Application for Works Approval

Works Approval Number W6813/2023/1

Premises Pinjarra Alumina Refinery
South Western Hwy
PINJARRA WA 6208

Date of report 11 June 2024

Figure 1: Location of the existing RFP1 (1-4 and 10) and proposed RFP2 (5 and 7-9)

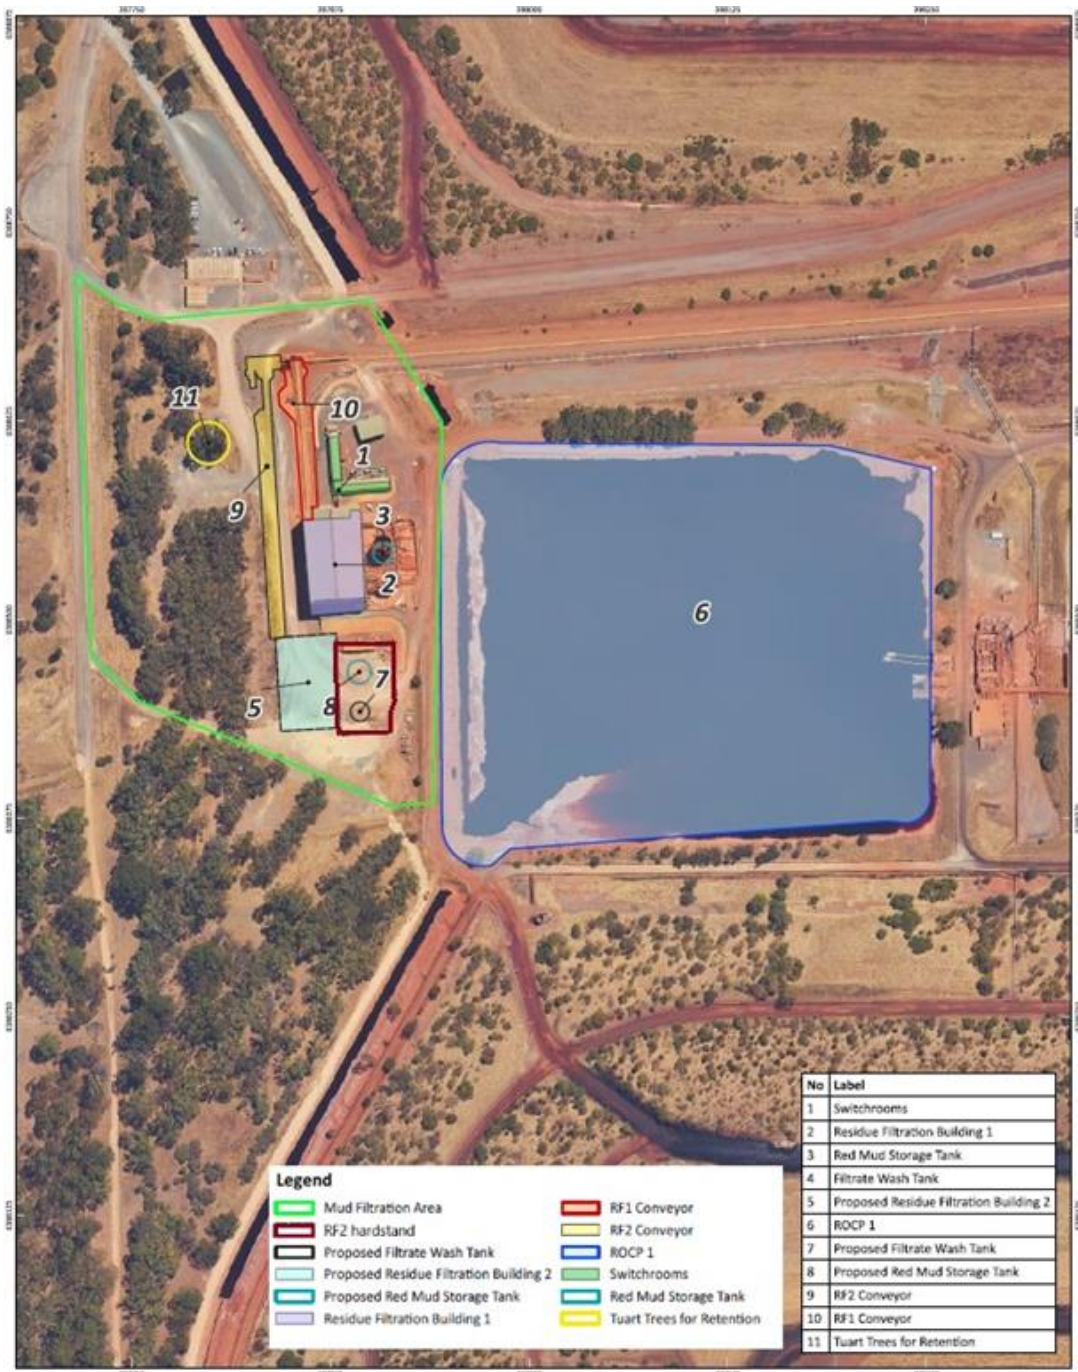
Decision report comments received on 8 February 2024		
Section 2.4 Premises overview	Applicant confirmed 2018 was correct date for establishment of RFP1 Figure 1 was provided indicated hardstand.	Delegated officer notes comment and has updated Figure 1
Section 2.4.1 Construction and infrastructure	Applicant confirmed that infrastructure listed is correct and requested the volume and specifications of the tanks to be removed as this has yet to be determined.	Delegated officer notes this and has updated the list.
Section 3.1.2 Operation	The applicant confirmed that RFP2 listed noise controls will be implemented. The applicant is still yet to determine which noise control will be undertaken on existing infrastructure and requested removal of RFP1 noise controls to provide flexibility to implement noise controls which achieve no net increase in noise.	The delegated officer notes that the applicant has demonstrated that zero net noise emissions can be achieved through retrofitting RFP1 other areas within the premises and new infrastructure noise control works for RFP2. Requirements for RFP1 retrofitting will not be removed unless the applicant can provide alternative controls that can be conditioned and demonstrated through a noise modelling report. The department is required under its Guidance Statement-Condition Setting, that conditions are valid, enforceable, risk based, outcome-based, site specific, documented and justified. Flexibility that involves not providing details of noise controls does not align with the department's guidance statement. The delegated officer notes the issues around access and has updated wording to reflect the intent.
